UNITED STATES ENVIRONMENTAL PROTECTION AGENCY

Subject: Notice of Disapproval of:

- Draft Remedial Investigation Report, Operable Unit 3, dated March 30, 2018 ("Draft OU3 RI Report")
 - Draft Baseline Human Health Risk Assessment, Operable Unit 3, dated March 30, 2018 ("Draft OU3 BHHRA")
 - Draft Operable Unit 1 & Operable Unit 2 Feasibility Study, dated March 30, 2018 ("Draft OU1 and OU2 FS Report")
 - Draft Operable Unit 3 Feasibility Study, dated March 30, 2018 ("Draft OU3 FS Report")
 - Containment Area Bedrock Boring Results, Olin Chemical Superfund Site (OCSS) in Wilmington MA, dated May 10, 2018
 - Revised Rock Matrix Sampling Work Plan (July 6, 2018) and related information provided by Olin/Wood in a letter dated June 29, 2018
- (Collectively, the "March 2018 RI/FS Deliverables"), Olin Chemical Superfund Site, Wilmington, Massachusetts ("Site")

Figure 11 - Interpreted Groundwater
Contours Inside Slurry Wall
May 6, 2016

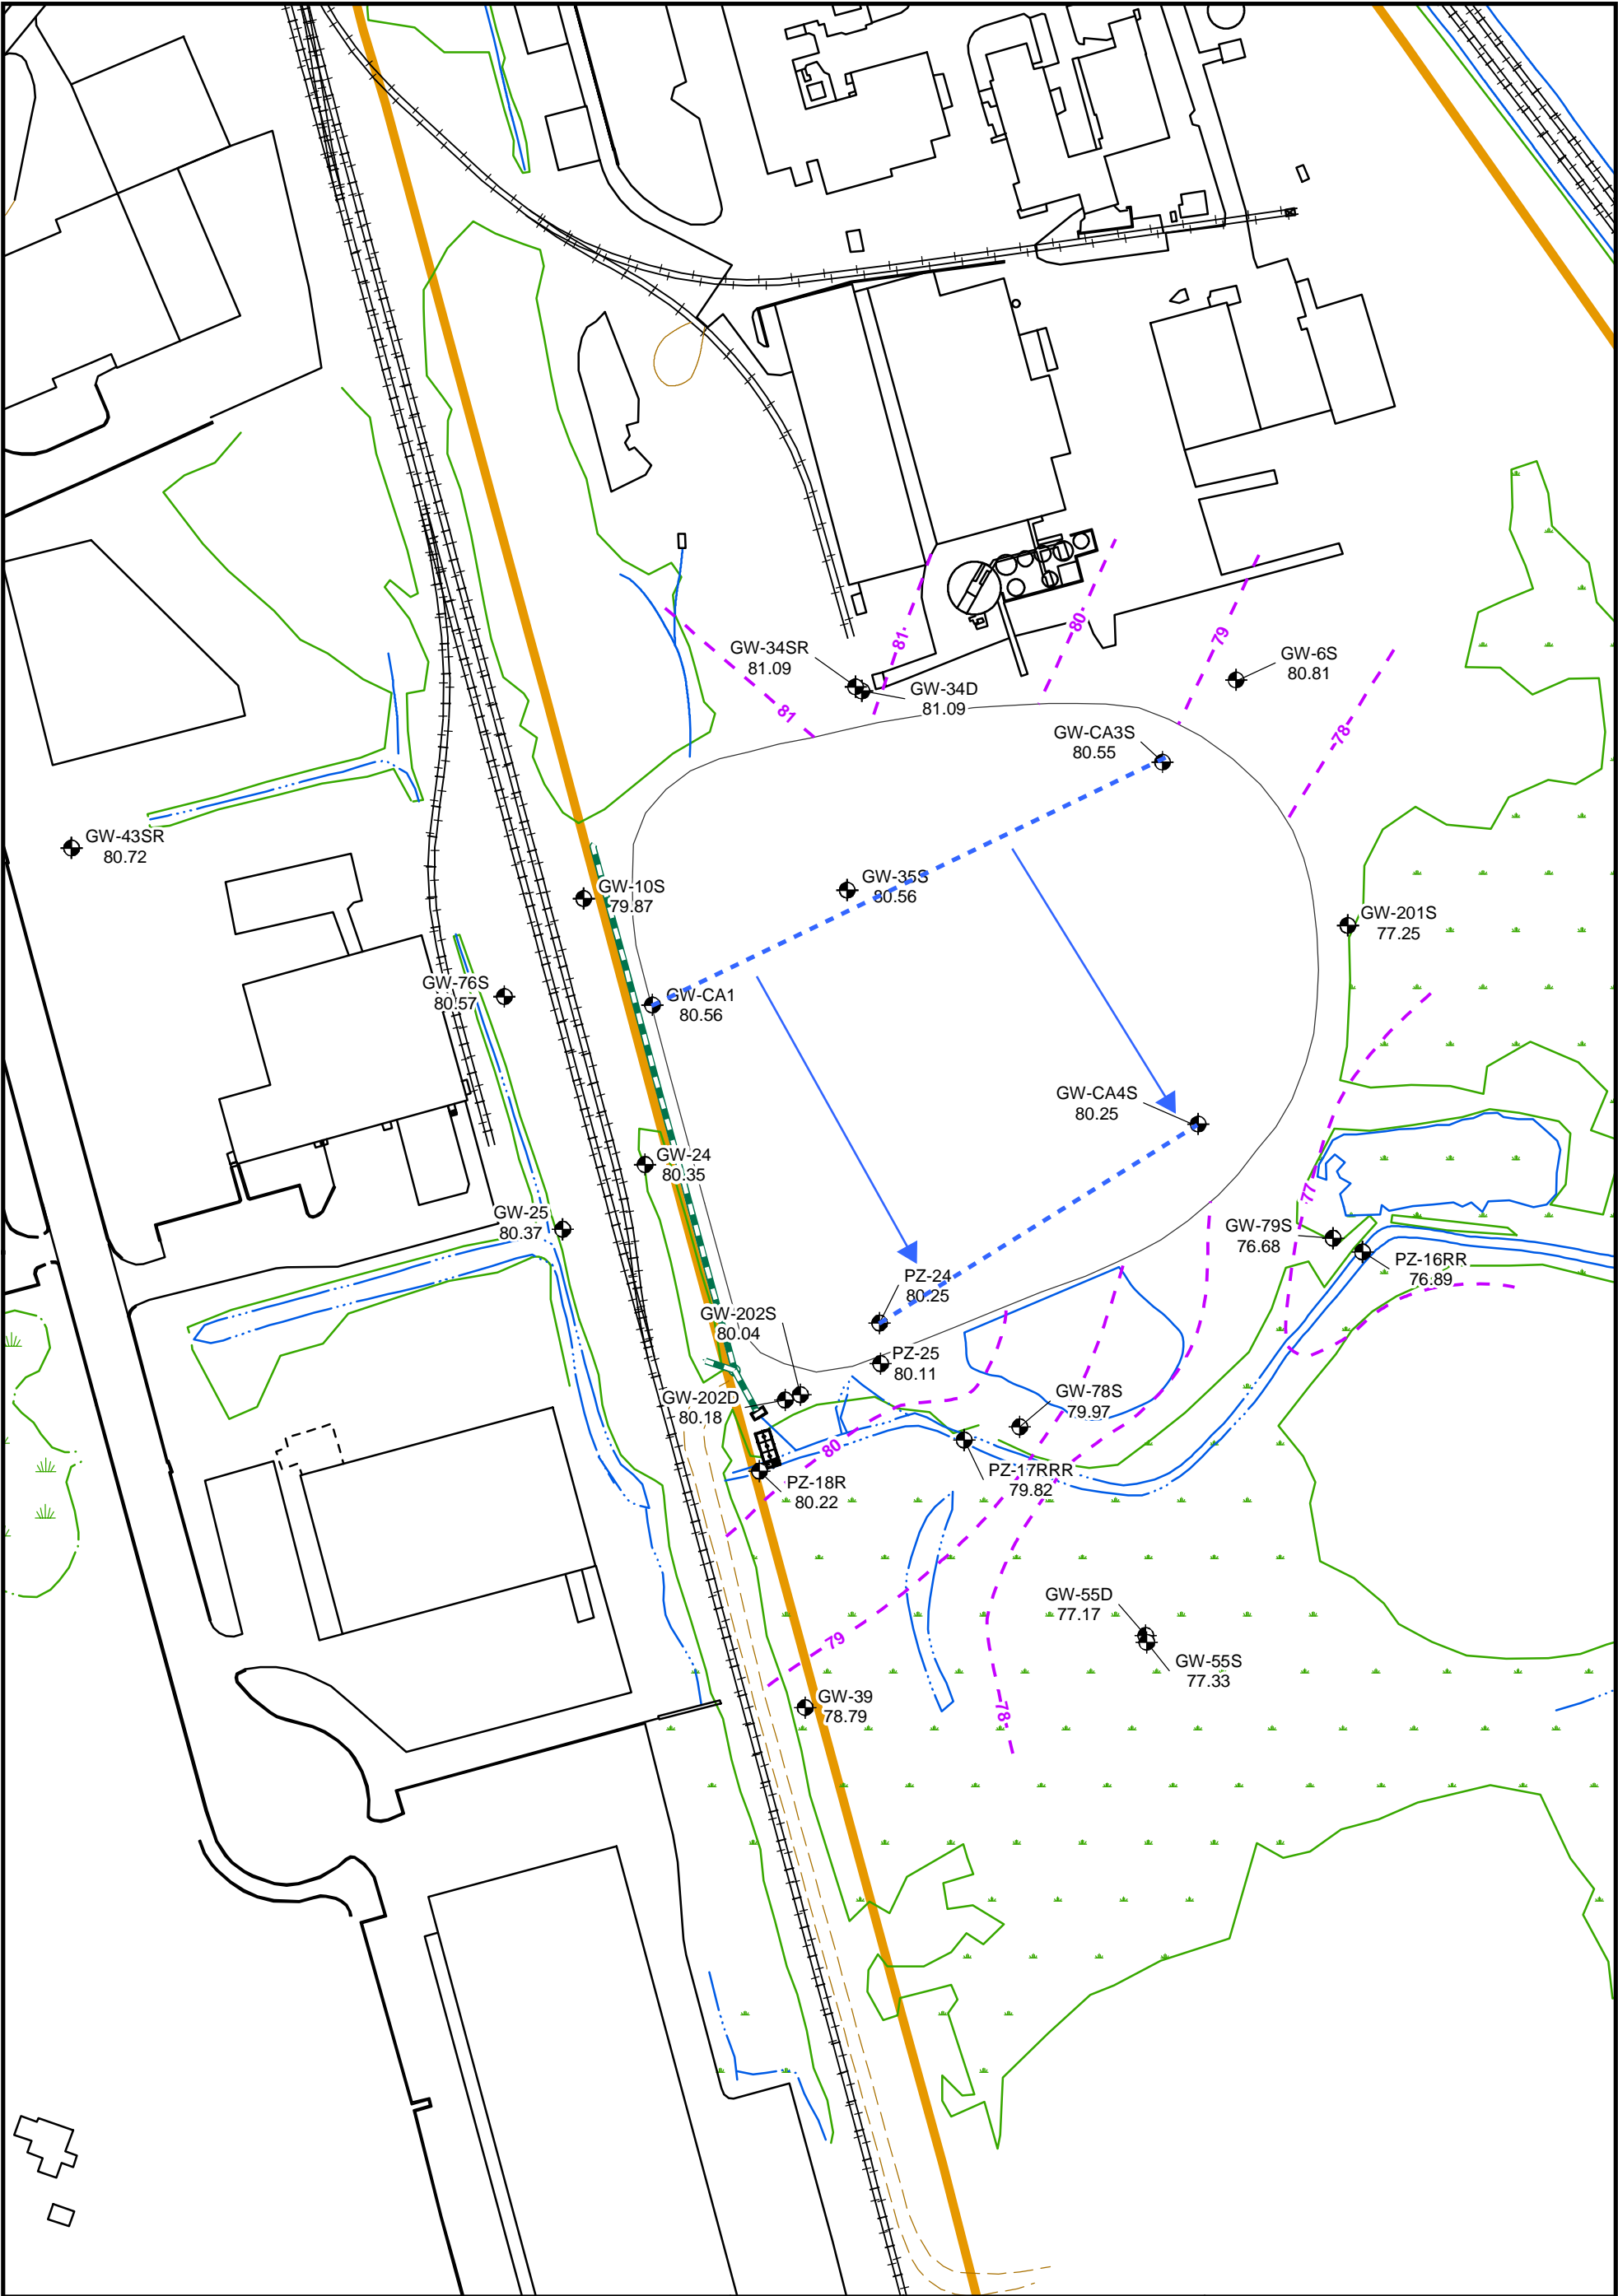
Within the containment area, if fully isolated from the outside water surface elevations, water surface contours should be semi-circles or semi-ellipses around the equalization window. Simply, a mound of water is spreading out away from the equalization window. Figure 11 (attached) of Olin's HPIT Phase II report presents this case for May 6, 2016 high groundwater condition. The groundwater elevations are a series of semi-ellipses contours around the equalization window. Conversely, a similar figure in October for low groundwater would have similar ellipses, but the lowest contour would be at the window and increasing elevation contours of semi-ellipses away from the window. Again, if the slurry wall is functioning as intended, points equi-distant north and south from the equalization window would have the same water surface elevation in the containment area.

To further examine the water surface elevation data, the data from Appendix E of the HPIT Phase II Report figures were entered into a spreadsheet and plots made between two well points. A figure is attached that presents the data selected plots. For example, GW-CA1 (at the window) is always higher than PZ-24 (the southwest corner of the containment area). Always higher! This indicates that flow is always going from GW-CA1 to PZ-24. The only place for the flow to go at PZ-24 is through (or under) the slurry wall. Similarly, either there is no flow or flow is going from GW-CA3S (northeast corner of containment area) to GW-35S (center portion containment area) 8 out of 9 times. Clearly, GW-35S being nearer the window should be higher part of the year than GW-CA3S. Again, there must be an additional flow source besides the window. Groundwater flow is occurring either through (or under) the north slurry wall. These findings indicate that a 'tilt' of the internal water contours is occurring due to the influence of the outside water table. The north side is higher and the south side is lower in the internal water table. So, the containment area is not isolated from the outside. Flow is occurring into the area from the north and out of the containment area in the south. The route of the flow is not known. The flow could be through the slurry wall, through the slurry wall and bedrock interface, through the weathered bedrock surface or through the bedrock fractures.

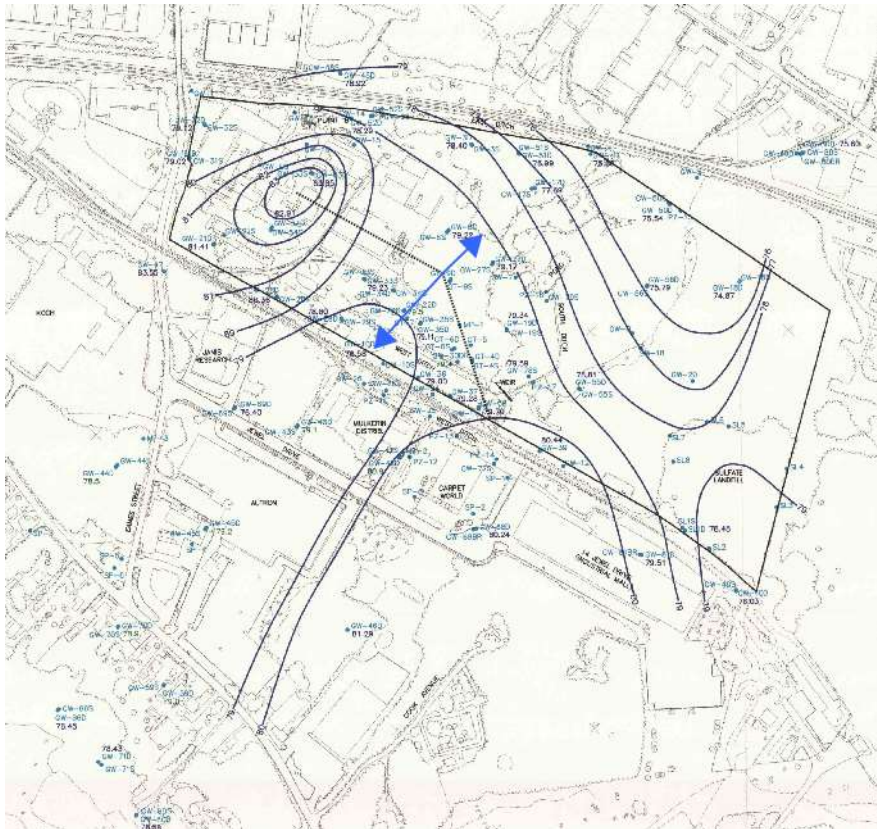
3. Page 1-11 Diffuse Layer. *This diffusion results in the presence of a “Diffuse Layer” which is a three to five-foot thick layer of groundwater that overlies the DAPL, and is defined by specific conductance between 20,600 and 3,000 μmhos/cm.*

a. Olin should provide support why 3,000 μmhos/cm was selected as the top of the “Diffuse Layer”. Is it arbitrary? Or did it define a concentration in another parameter, SG, SC or other? Vertical profiles of the parameters are needed as noted in comment #1.

Figure 5. Potentiometric surface map based on shallow wells, April 1998.

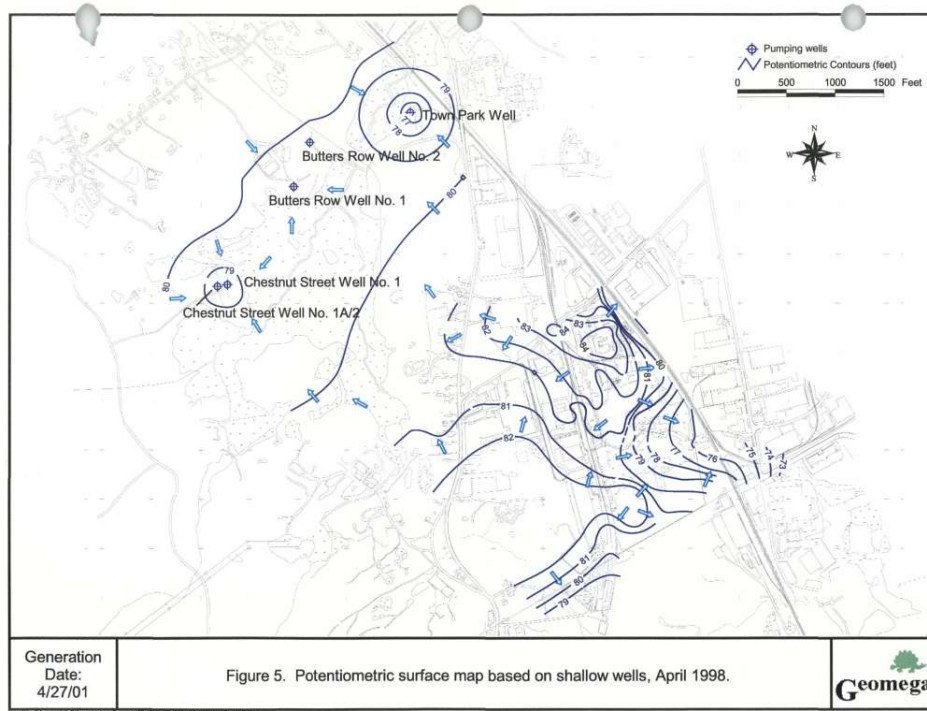
4. Page 1-12 Watershed Divide. Olin states the location of the current watershed divide but fails to recognize (or wishes to ignore) the data which indicates the watershed divide can be on the site when the municipal wells are pumping. The watershed divide being on the site explains why most of the contamination is in the Ipswich watershed and not the Aberjona watershed. The figure below is from Interim Update Investigations, Smith, June 1996.

Additionally, in Olin Wilmington Technical Series XIV. A Groundwater Flow and Solute Transport Model April 2001 by Geomega provided the groundwater information for April 1998.
